FIELD INSPECTION

Project Name:	Mountain Valley Pipeline	Inspector:	Matthew Grant
Inspection Date:	Tuesday, March 5, 2019	Project Contact:	Brian Clauto
Spread: Pittsylvania County MP 299-300 St#15838-15865 MP285 St#15084-15092 MP270 St#15055+88	Spread I	Weather (Wet/Dry/Rain):	Wet

FIELD INSPECTION PHOTO LOG

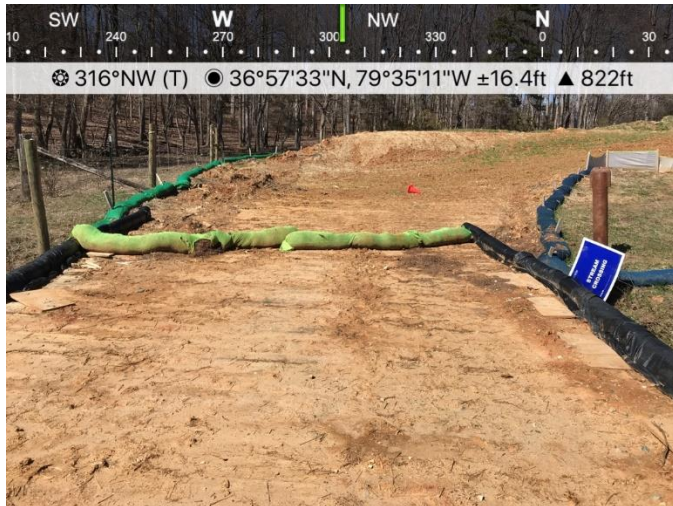
- Fig. 1 St#15850+56 stockpile lacks stabilization

- Fig. 2 St#15865+00 level spreader lacks end cap

- Fig. 3 St#15084+00 CWD has been breached

- Fig. 4 St#15086+00 CWD inlet has eroded

Recommended Corrective Action: Maintain all controls per the approved plan and specs, remove sediment and stabilize per DEQ approval.
